CITY OF ALBUQUERQUE

Re: 3308 4th Street Apartment Building
3308 4th Street NW
Traffic Circulation Layout
Engineer's Stamp **06-04-18** (H14-D109)

Based upon the information provided in your submittal received 06-05-18, the above referenced plan cannot be approved for Building Permit until the following comments are addressed:

3308 4th SREET, NW SITE PLAN FOR BUILDING PERMIT

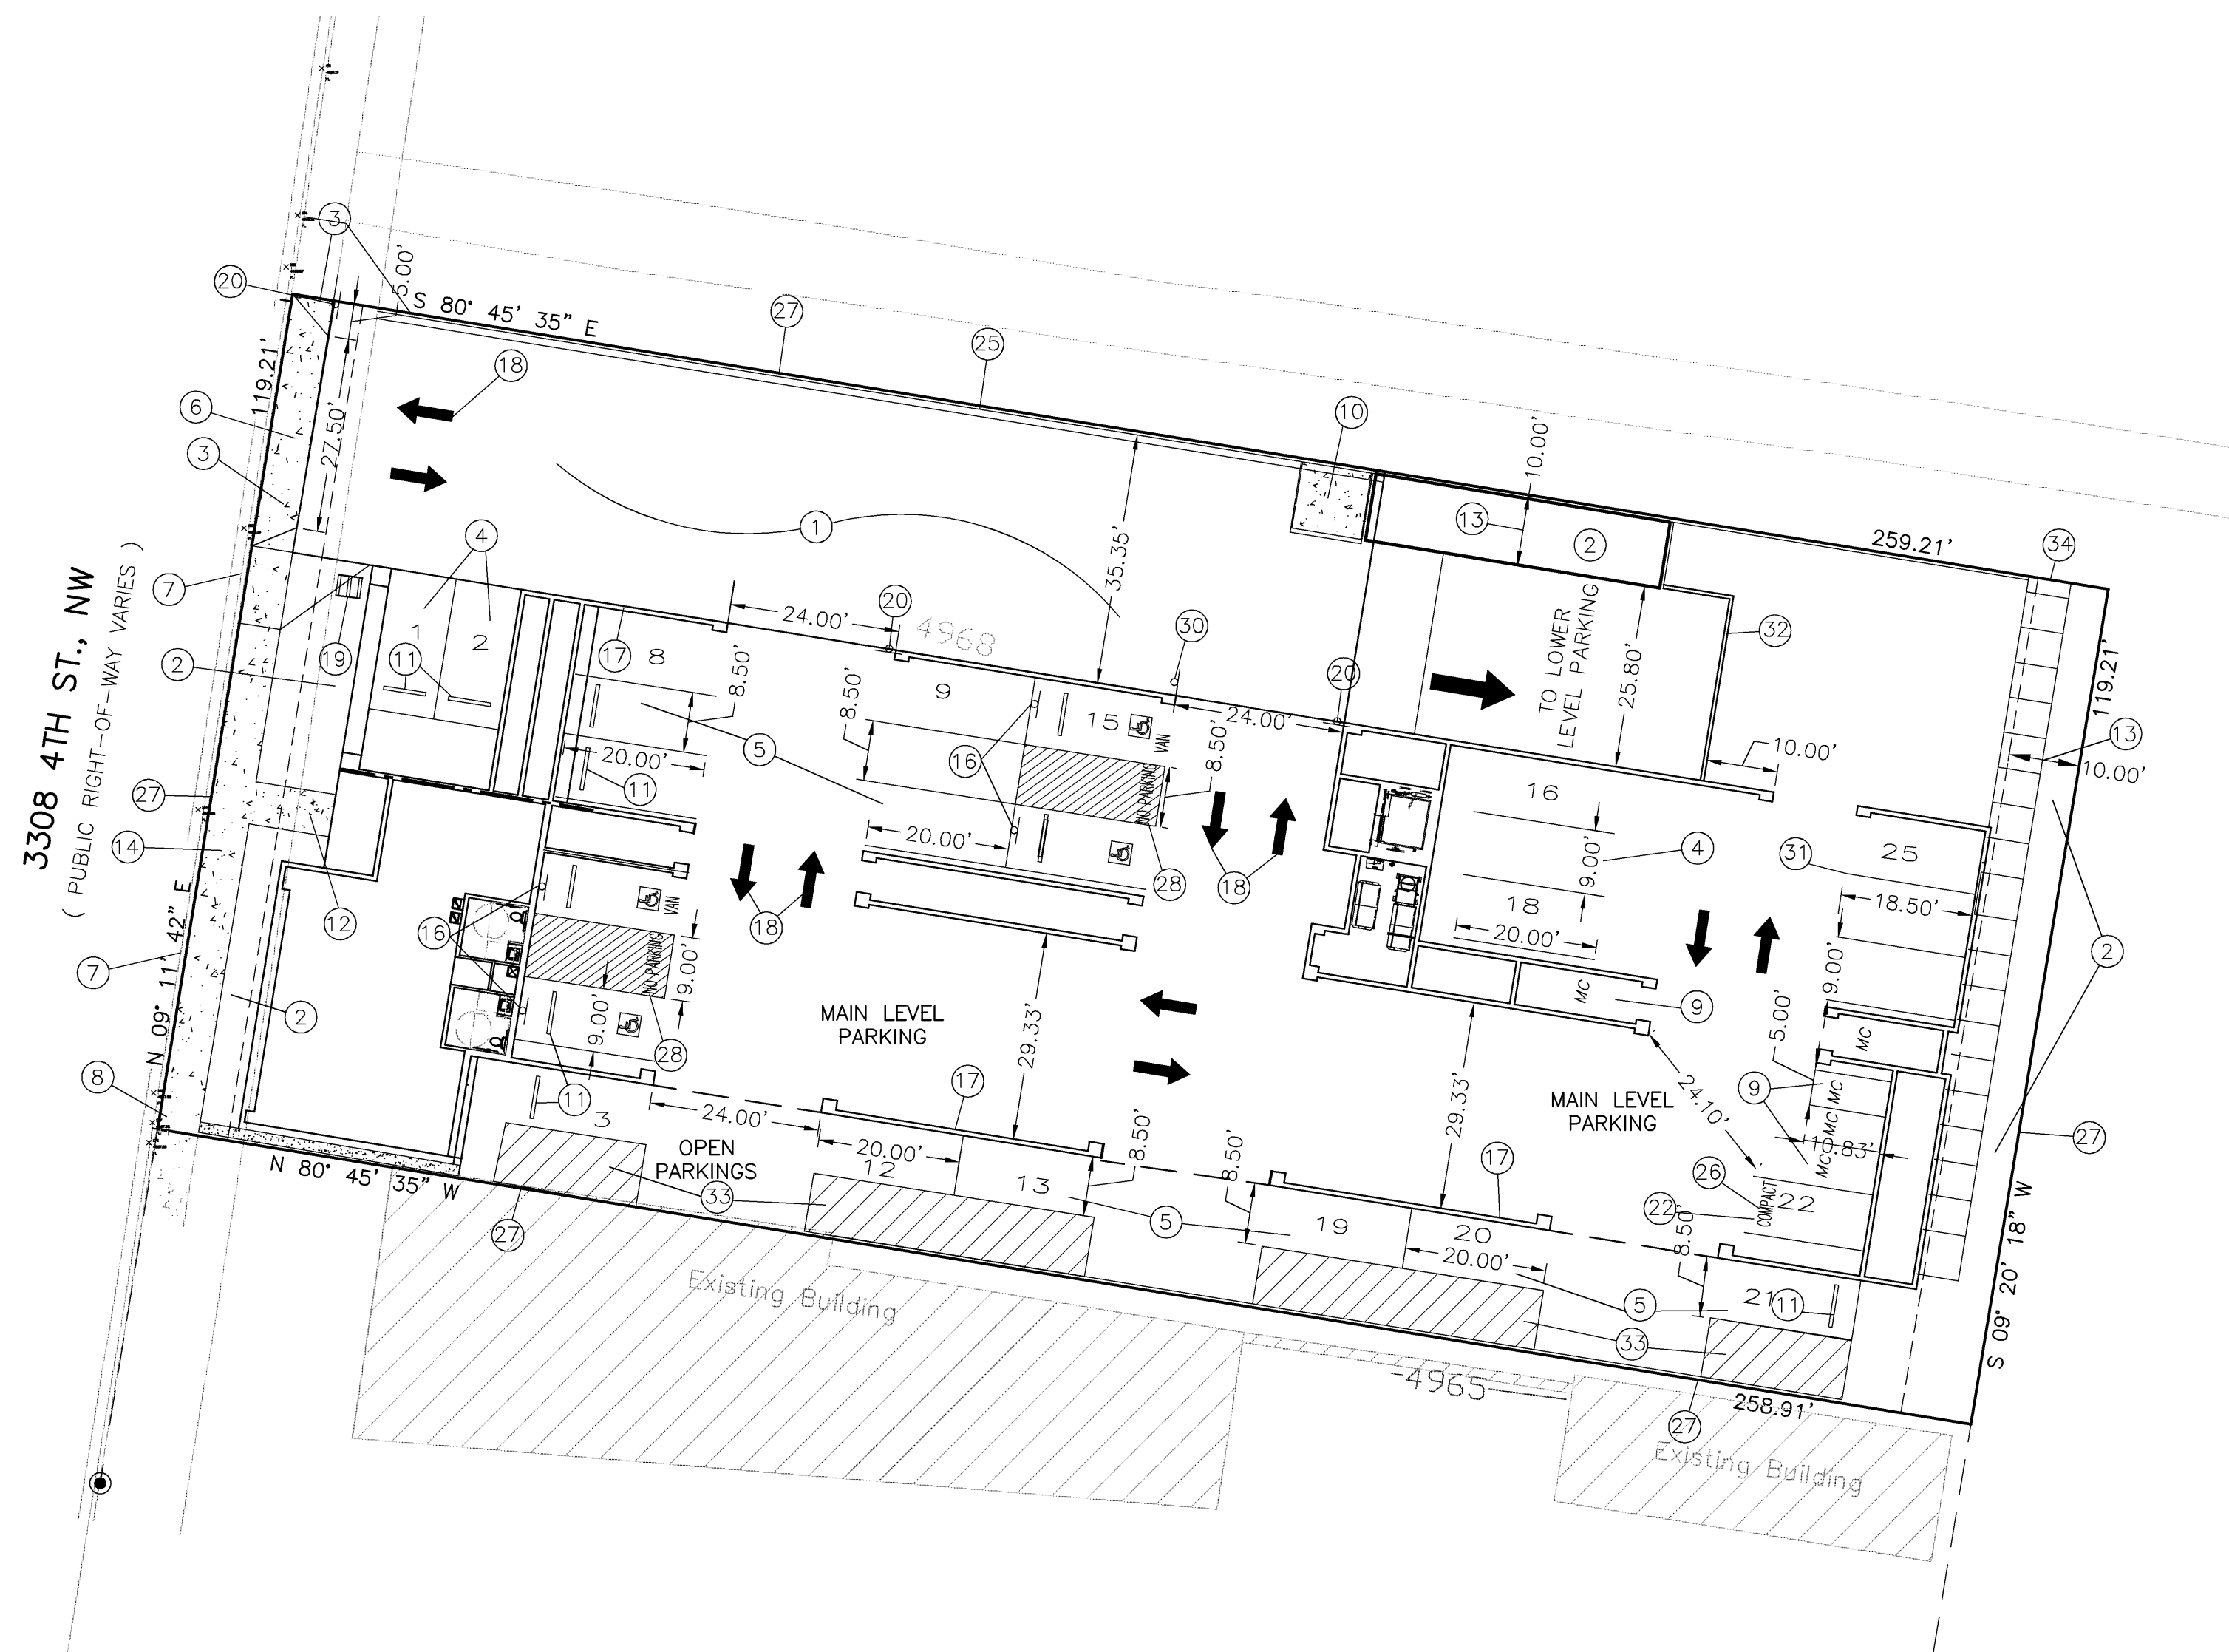
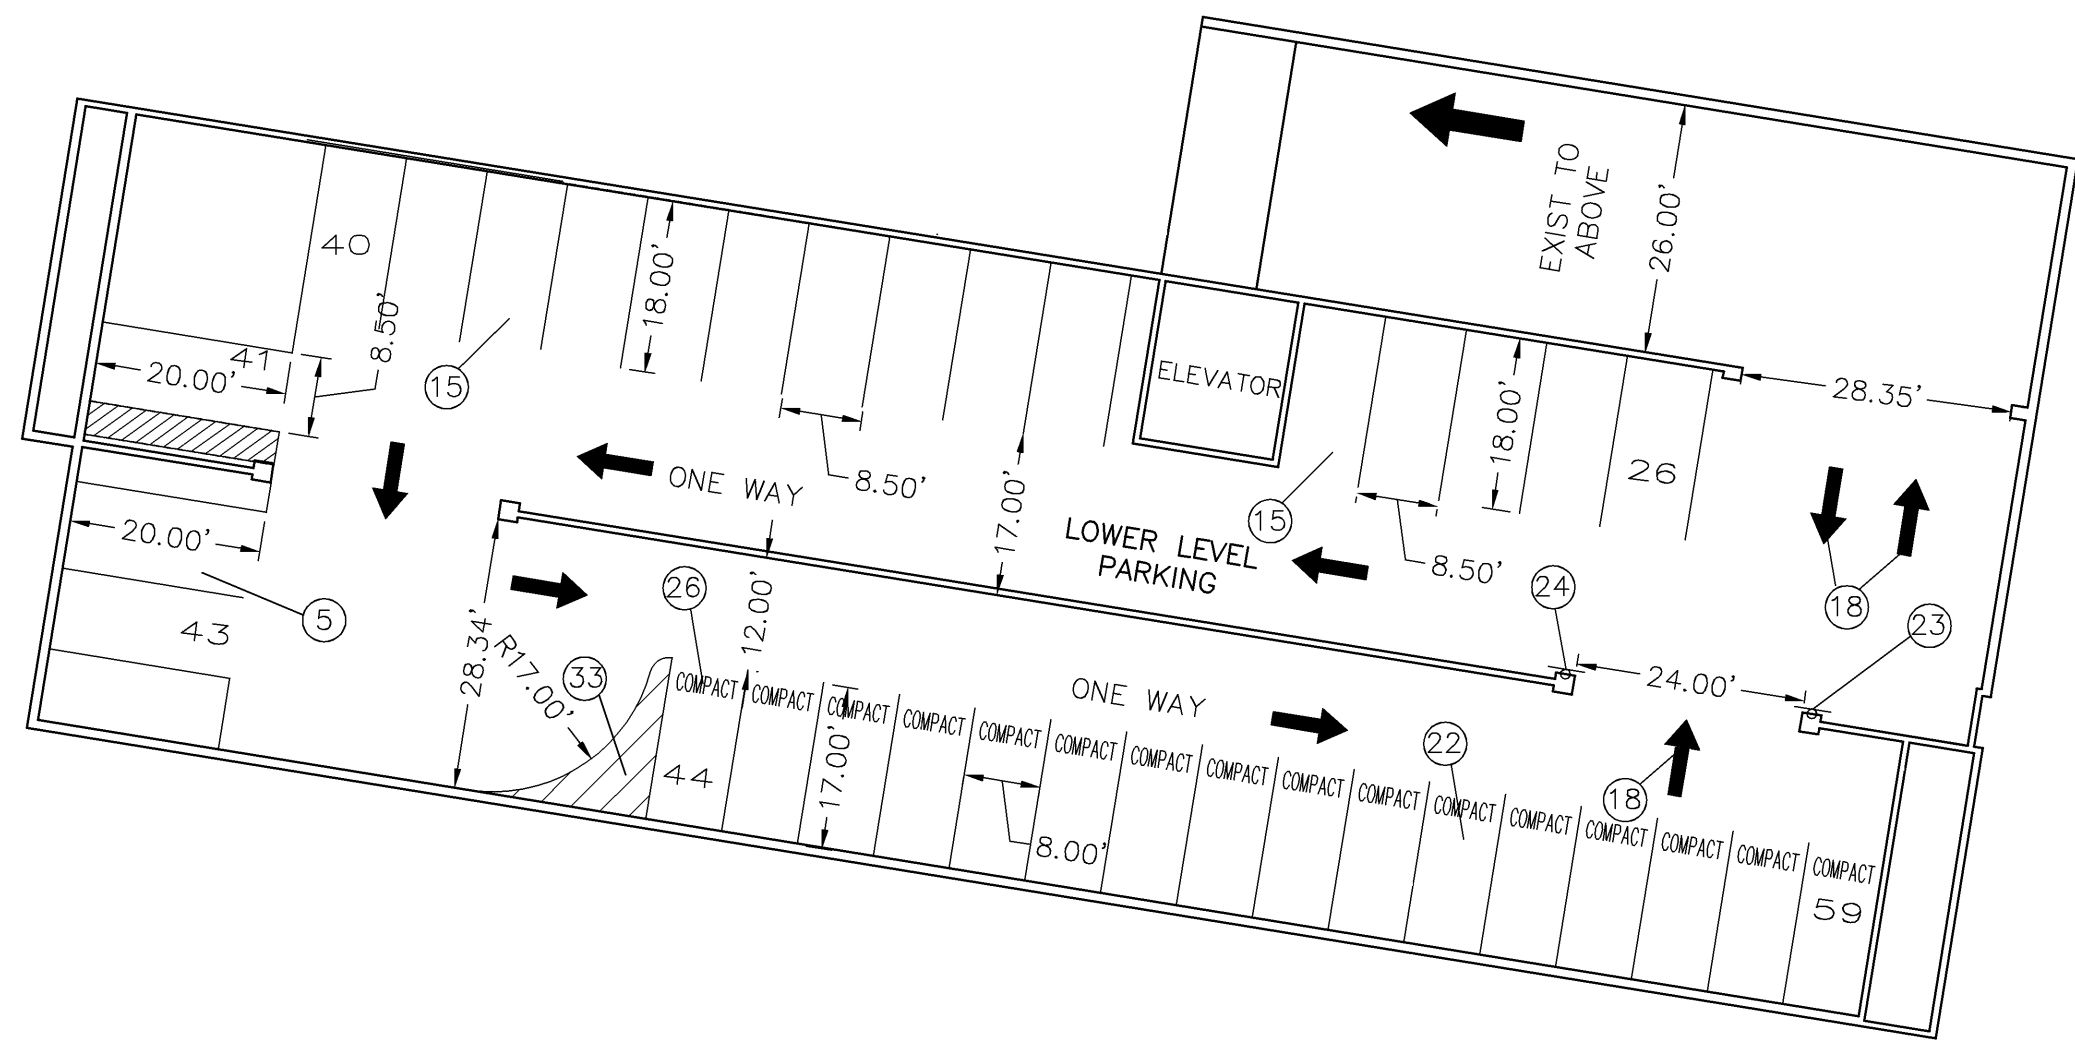
1. Please show the location of the Motorcycle parking sign on the site plan.
2. Please show the sidewalk connecting to the multi-use path.
3. Show the route refuse will use to access the trash bin.
4. Please show the locations of the doors on the stair-well and elevator. Also please label the stair-well.
5. Please provide an elevation exhibit for the parking structure showing doors and ceiling height.
